Access Compliance Report

Public Rights-of-Way

Intersection ID: 17140	Main Street: S_WENDOVER_RD	Cross Street: SEDGEWOOD_CR	Location: NW
ADA ID: 4591D28F3194	Ramp Type: PerpDiag	Initial Pass/Fail: Fail	Overall Compliance: No
Severity Score: 46.25			
Codes/Mitigation Info/Possible Solution		Field Measurements/Component Compliance

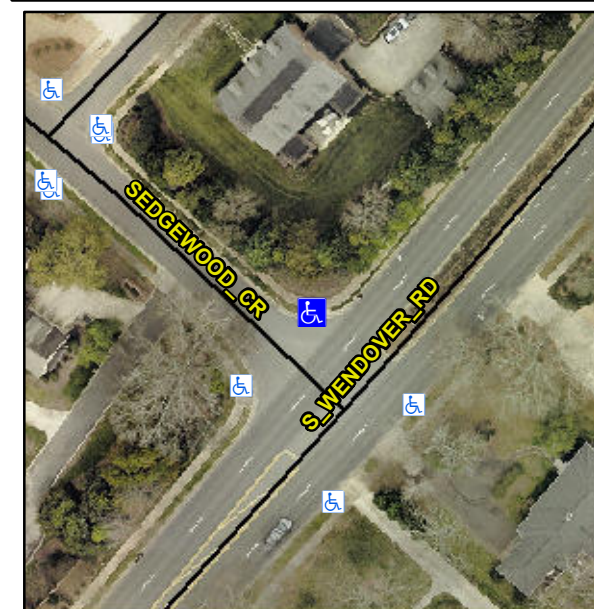
Not Found, R304.5.1, R304.2.2, R304.5.3

Compliance	Description	Data	Compliance	Description	Data
N/A	Ramp Length (in)	43.0	No	Ramp Slope (%)	13.6
No	Ramp Width (in)	40.0	No	Ramp XSlope (%)	5.8
N/A	Flare Type LT	N/A	N/A	Flare Type RT	N/A
N/A	Flare Slope LT (%)	N/A	N/A	Flare Slope RT (%)	N/A
N/A	Flare Traversable LT?	N/A	N/A	Flare Traversable RT?	N/A
N/A	Landing Length (in)	N/A	N/A	DWS Provided?	N/A
N/A	Landing Width (in)	N/A	N/A	DWS Contrast?	N/A
N/A	Landing Slope (%)	N/A	N/A	DWS Length (in)	N/A
N/A	Landing X Slope (%)	N/A	N/A	DWS Full Width?	N/A
N/A	Landing Curb? (Y/N)	N/A	N/A	DWS Offset (in)	N/A
N/A	Shared Landing?	N/A			
N/A	Gutter Ponding?	N/A	N/A	Gutter Slope (%)	N/A
N/A	Gutter Lip Ht (in)	N/A	N/A	Gutter X Slope (%)	N/A
N/A	Painted X Walk1?	No	N/A	Painted X Walk2?	No
	X Walk 1 Direction	To SW		X Walk 2 Direction	To SE
N/A	X Walk 1 Width (in)	N/A	N/A	X Walk 2 Width (in)	N/A
	X Walk 1 Slope (%)	2.8		X Walk 2 Slope (%)	1.0
	X Walk 1 X Slope (%)	1.7		X Walk 2 X Slope (%)	3.1

Remove & Replace Curb Ramp With Two New Directional Ramps or Equivalent.
